Re: Amendment to Special Development District Application #135-R1-14
2432 Albany Avenue, West Hartford, Connecticut

The undersigned hereby respectfully requests an Amendment to SDD#135-R1-14 to make revisions to building as more particularly set forth below.

**Amendment
to
Special Development District Application #135-R1-14
2432 Albany Avenue, West Hartford, Connecticut**

8 - (Up Down Light
South Façade)

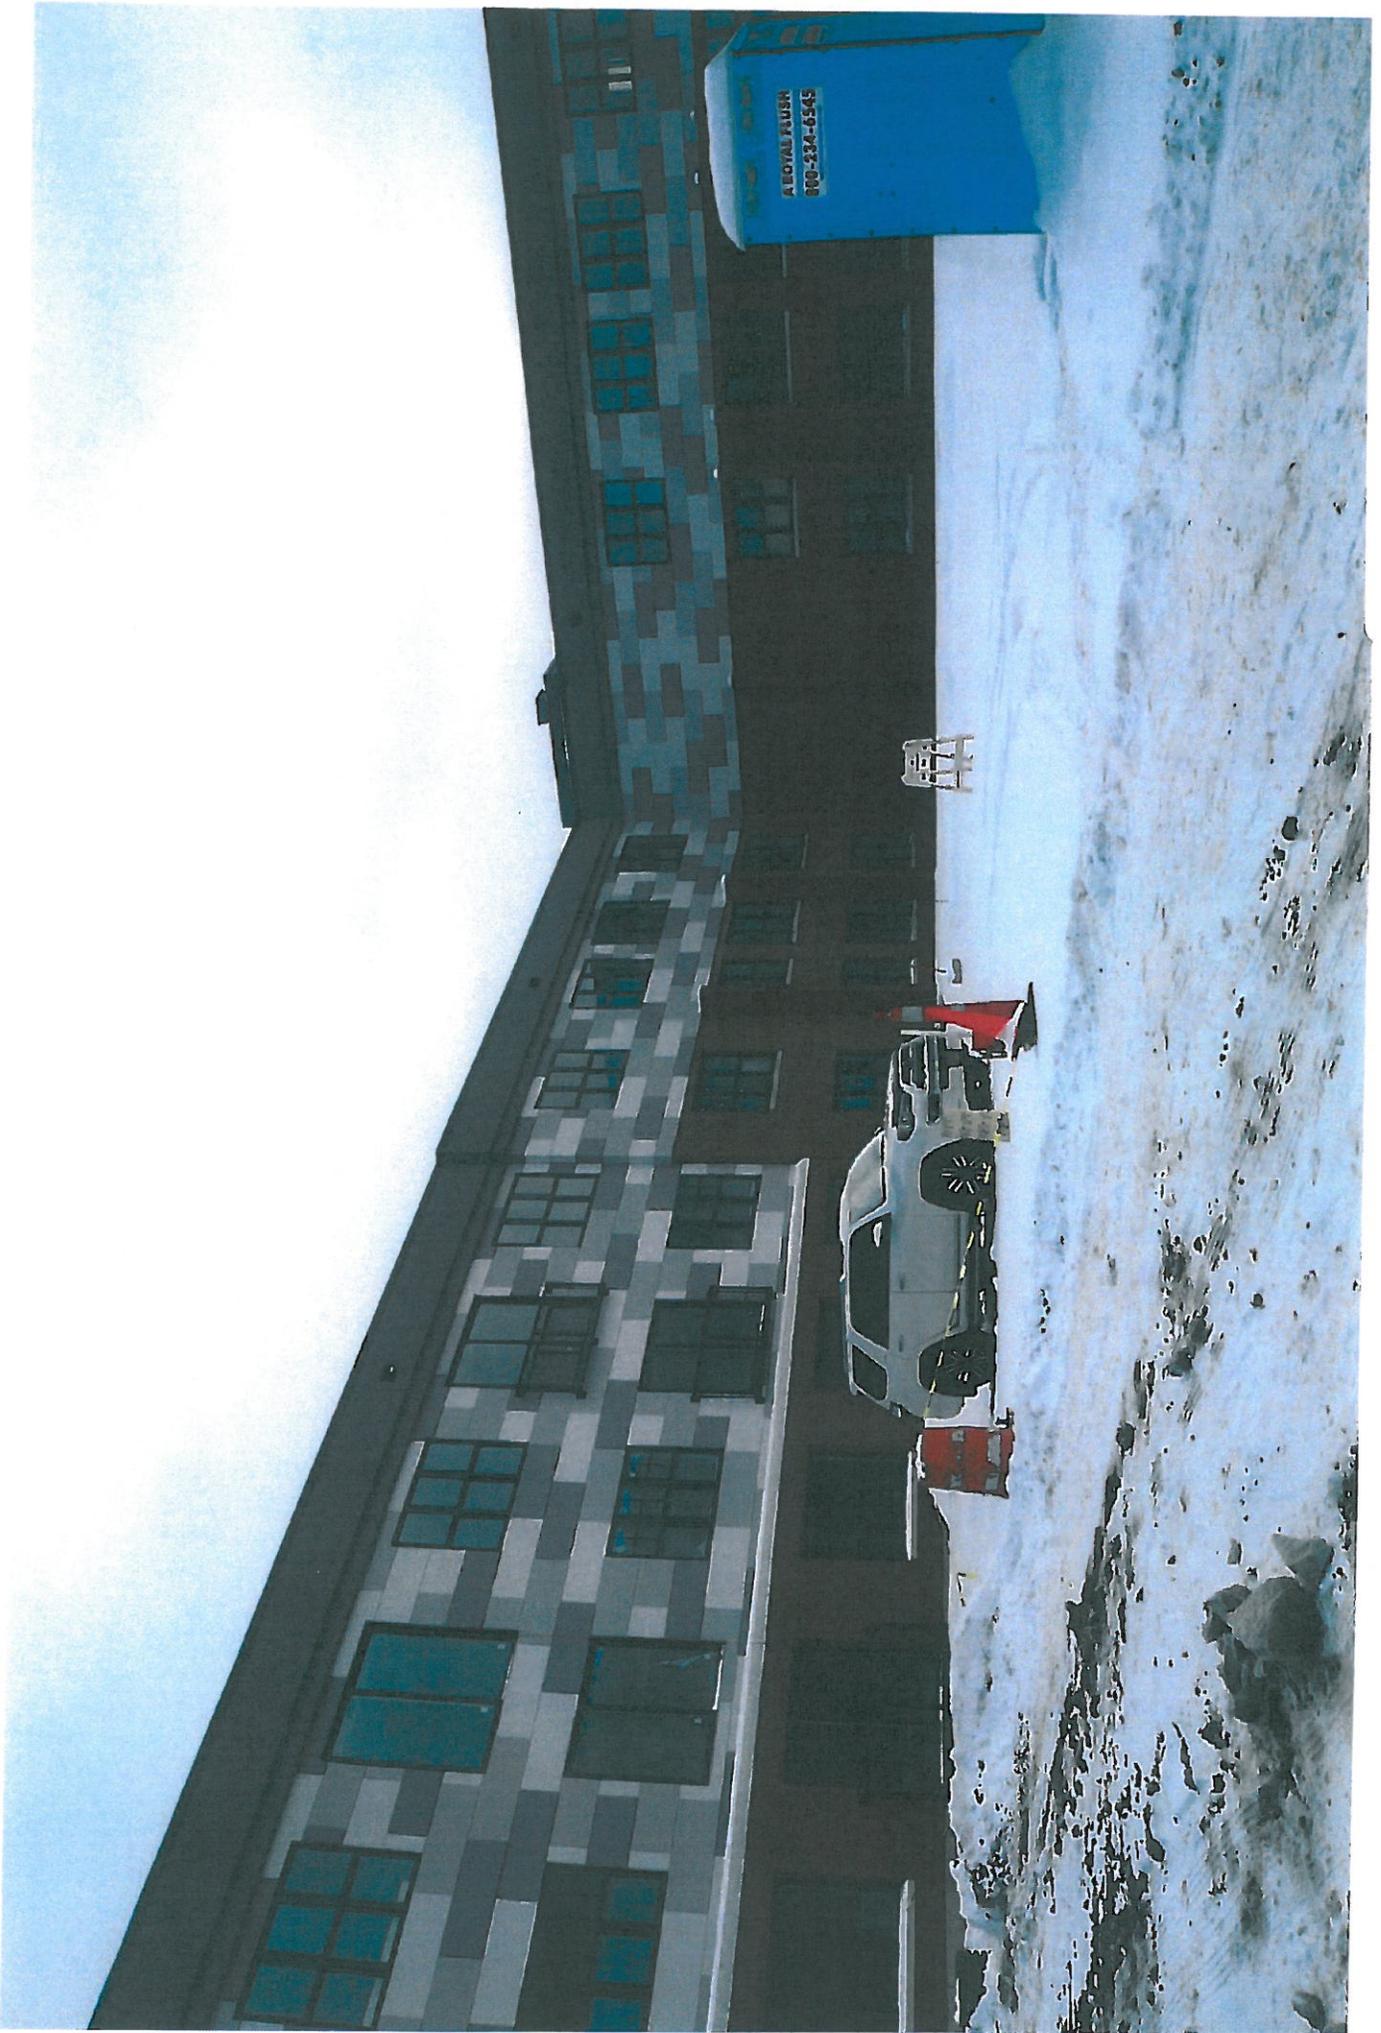
- Remove raised panels on entrance vestibule and make panels “flush”- 10 places (Aesthetic – see photo 7). This proposed change is not yet complete.
- Add 2 “up / down” exterior lights to south facade (building presentation) (see photos 2 and 8). Reason - Necessary to maintain critical path.

Double Face Monument Sign
Scale: 1" = 1'-0"

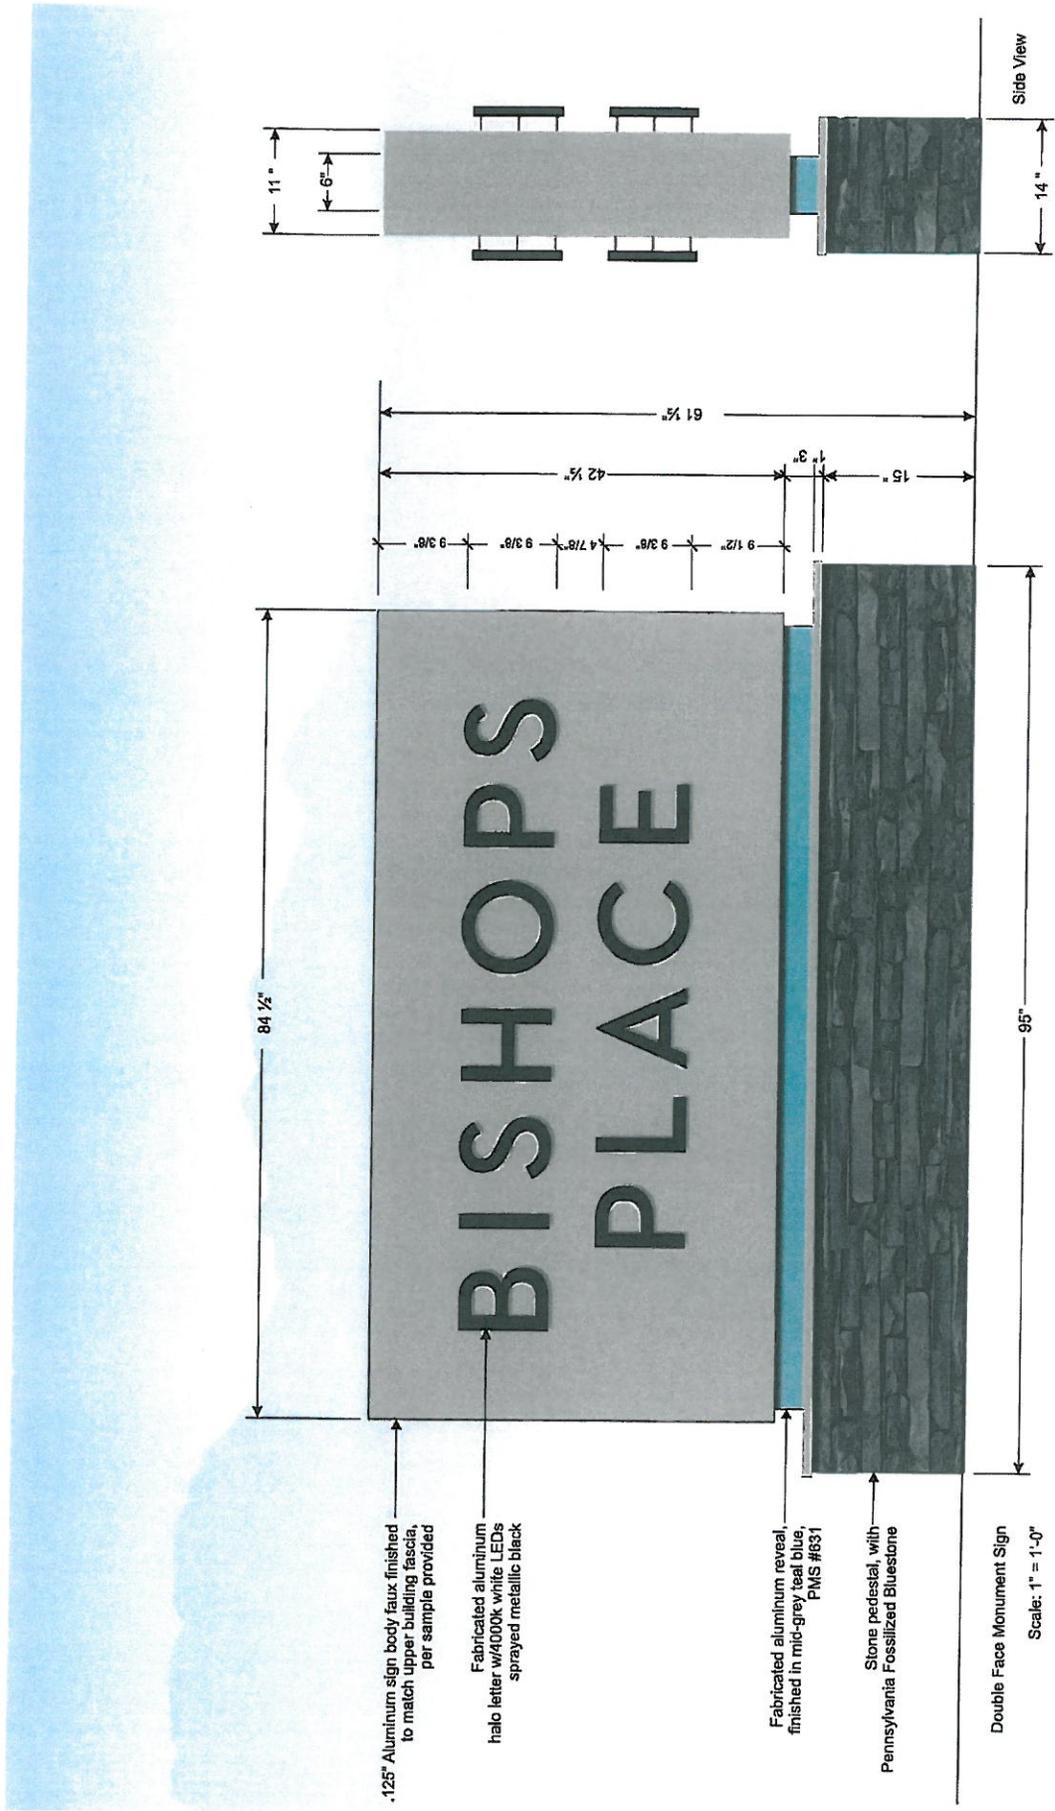
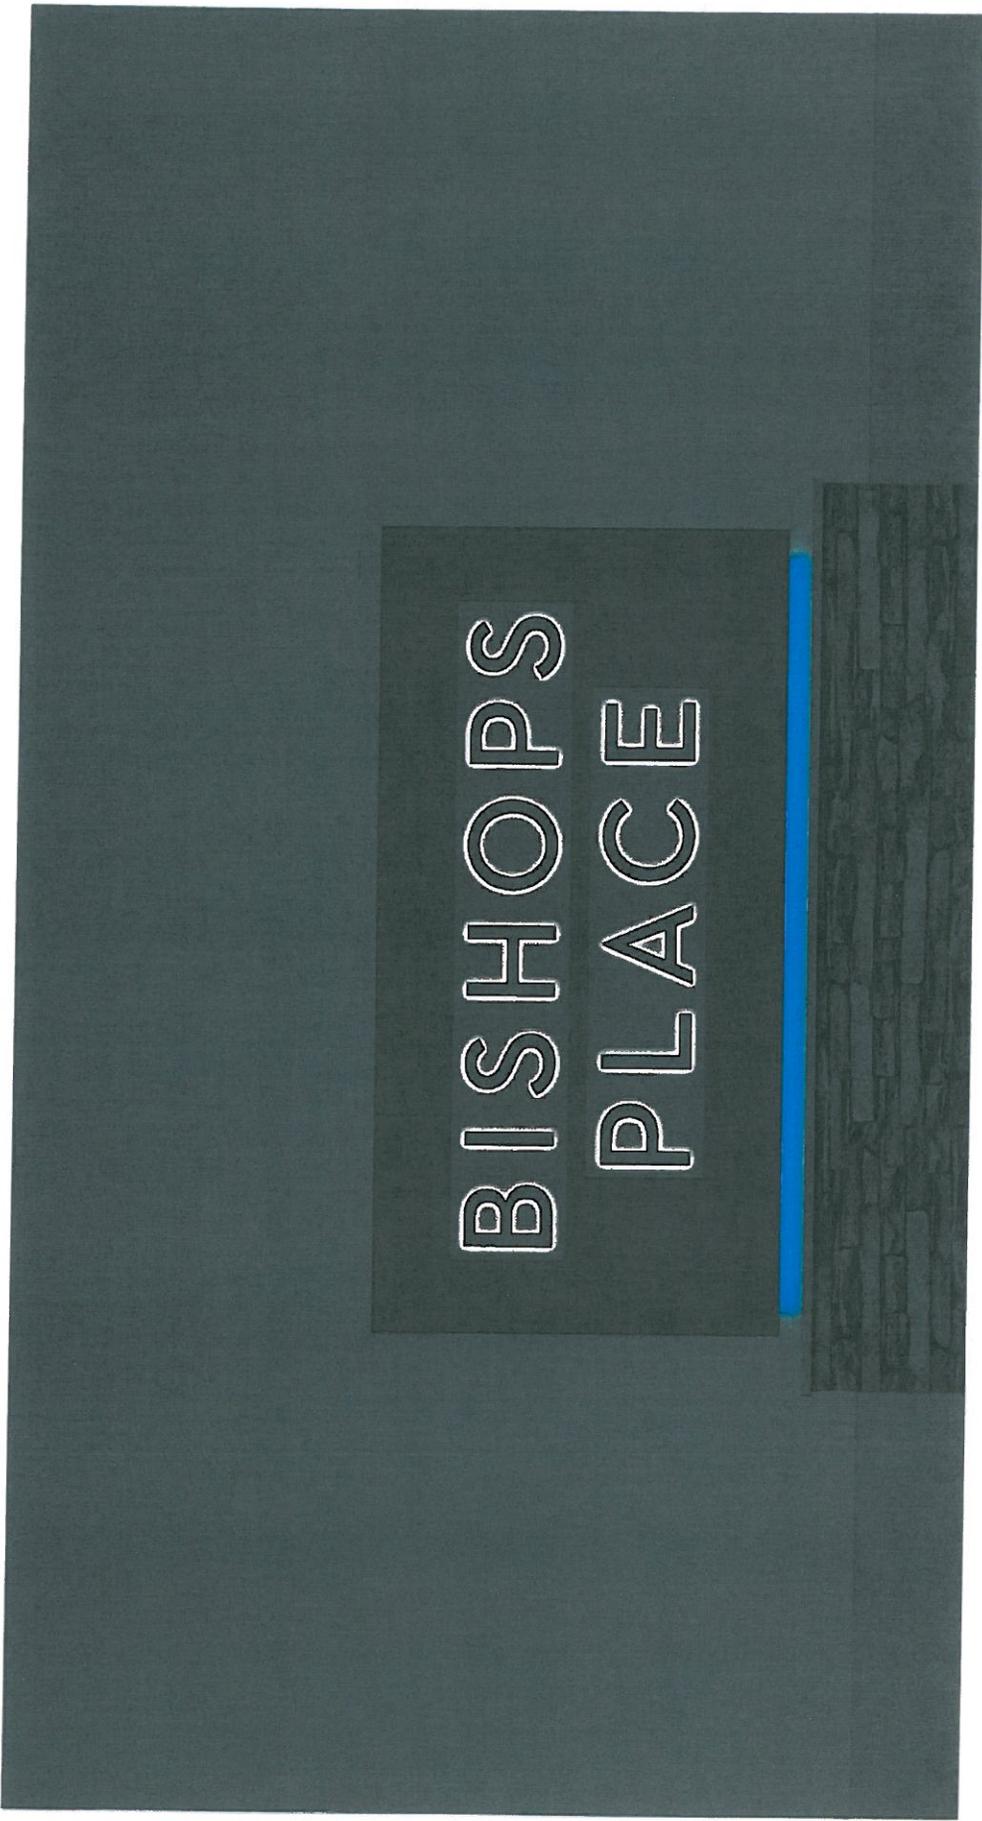
- Add detail of 5 entrance columns (SKL.1) – This change is not yet complete.
- Add detail signage on front of building; monument sign; “Bishop’s Place” at main building entrance. (see Artfx sheets 1-6) – This change is not yet complete.
- Delete Entrance sign and modify wall running along Albany - See Sheet SKL 6. Wall has been modified in contemplation of deleting the identification sign. Identification sign was deleted to avoid confusion since this is not the main entrance. Deletion of the sign - This change is not yet complete
